# City of Lee's Summit

TO: Planning Commission  
PREPARED BY: C. Shannon McGuire, Planner  
CHECKED BY: Hector Soto, Jr., AICP, Current Planning Manager  
RE: **CONTINUED PUBLIC HEARING – Appl. #PL2018-079 – REZONING from AG to RP-4 and PRELIMINARY DEVELOPMENT PLAN – Artisan Point Apartments, approximately 35 acres generally located at the northeast corner of SE Blackwell Rd and SE Blue Pkwy; Case Development, LLC, applicant**

Screen B	
Shade trees	1/1,000 sq. ft.
Ornamental trees	1/500 sq. ft.
Evergreen Trees	1/300 sq. ft.
Shrubs	1/200 sq. ft.

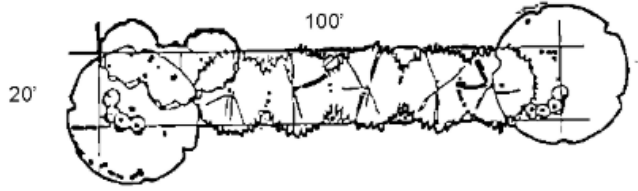
- Proposed – The applicant proposes to install a medium impact screening landscaping buffer along the northern property line. The medium impact landscape screen will meet one of the options as outlined in Article 8 of the UDO. The tables below outline the screening options as required by the UDO and provides a visual representation for each.

- Recommended – The medium impact screening will provide a 70 percent semi-opaque screen between land uses which are dissimilar in character. This semi-opaque screening will partially block views from adjoining land uses and create a separation between the adjoining properties. The applicant proposes to set the apartment buildings back from the northern property line approximately 135' to 204'. In addition to the proposed landscaping buffer the applicant has located the required storm water detention basin between the proposed buildings and landscaping buffer thus creating an additional buffer between the land uses. As seen in the below illustration, with the significant distances, a six (6) foot fence will have a negligible effect in providing a screen to the nearby residential homes. For these reasons staff believes the proposal to be reasonable and supports the requested modification.
